National Park Service
U.S. Department of the Interior

National Mall and Memorial
Parks

April 27, 2016

Re: Section 106 VASHPO Consultation on the Kennedy Center Expansion Connection Project

Figure 1: Revised Area of Potential Effects (APE) map illustrating the APE in a dashed purple line. Note that the APE excludes the “blade” of the Memorial Avenue Corridor (brown), but includes a section of the Arlington National Cemetery Historic District (pink).

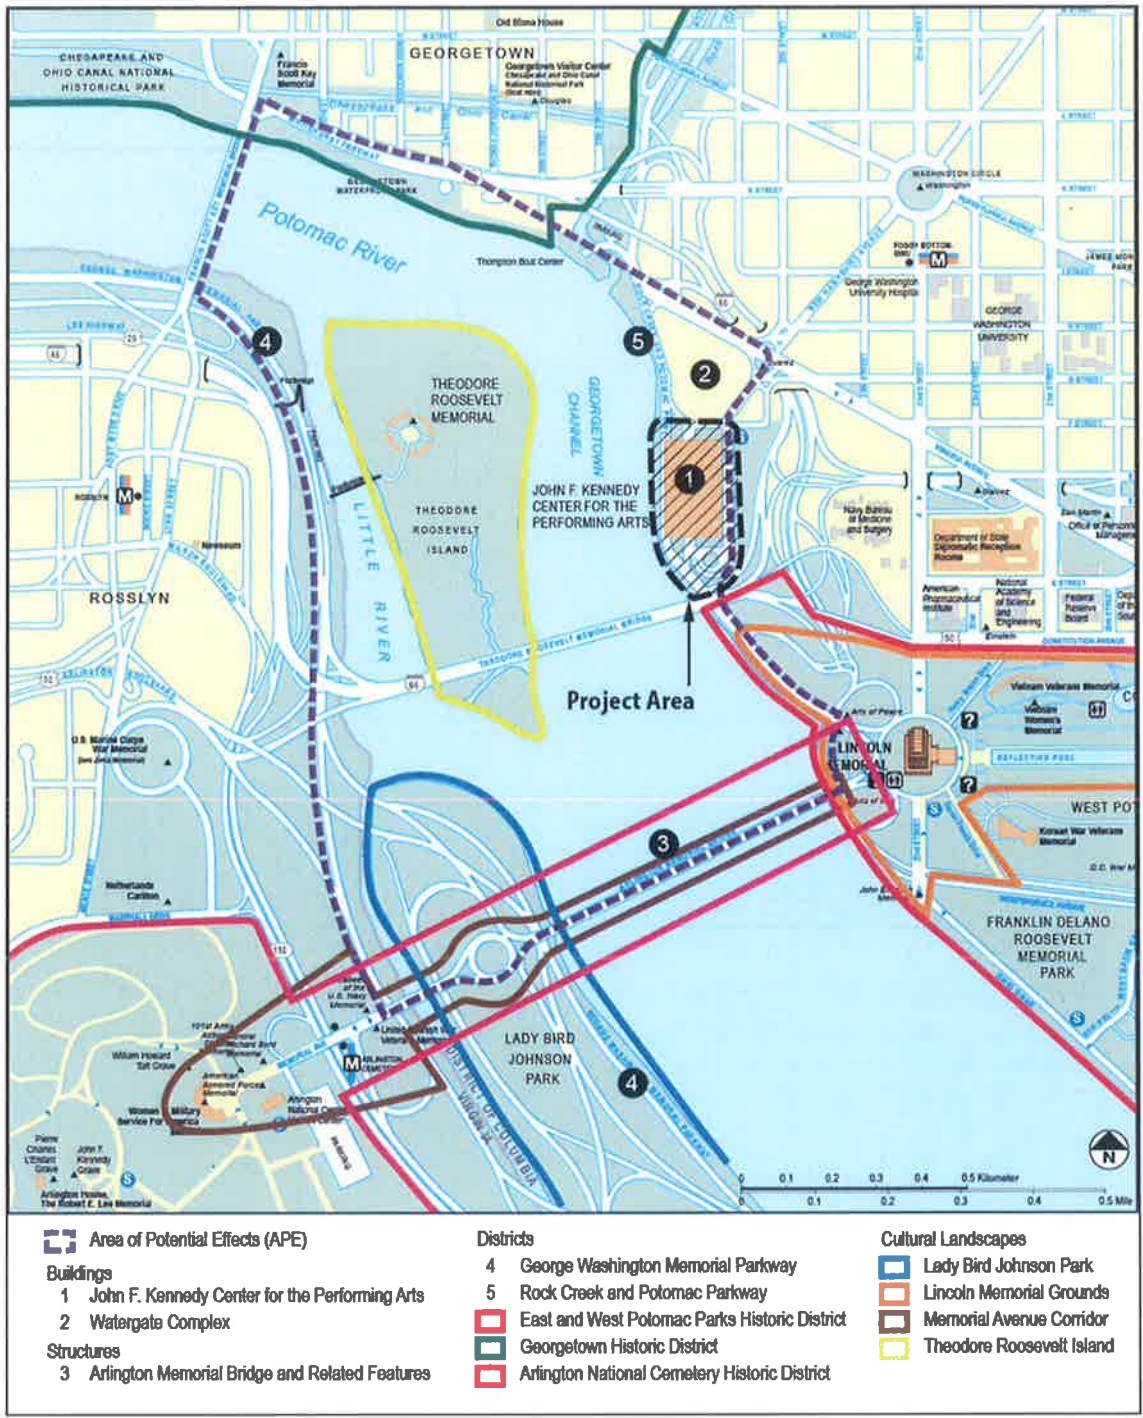
Area of Potential Effects. A draft Area or Potential Effects (APE) was identified by NPS and NCPC through consultation with the DCHPO and other consulting parties and was presented for public comment during a joint NEPA/Section 106 public scoping meeting on September 29, 2015, and during a Section 106 consulting parties meeting on December 10, 2015. The APE was illustrated in a map included as Figure 6 in the draft AOE. As a point of clarification, this map illustrated the boundary of the APE using a solid black line, and the brown line represented the boundaries of the Memorial Avenue Corridor. As such, the APE does not include the "blade," which is part of the of the Memorial Avenue Corridor, nor

does it include the Arlington Memorial Cemetery Hemicycle. To clarify this issue, the APE map will be revised to more clearly differentiate between the APE boundary and the boundaries of various resources. (See enclosures.) The viewshed analysis indicates that the Kennedy Center Expansion Connection project area would not be visible from the Arlington Memorial Cemetery Hemicycle; therefore, this resource is not included in the APE. (See enclosures.) Lastly, in response to the request for clarification regarding the images in the AOE taken from the Virginia side of the Potomac River, the locations and directions will be clearly described in the photo captions.
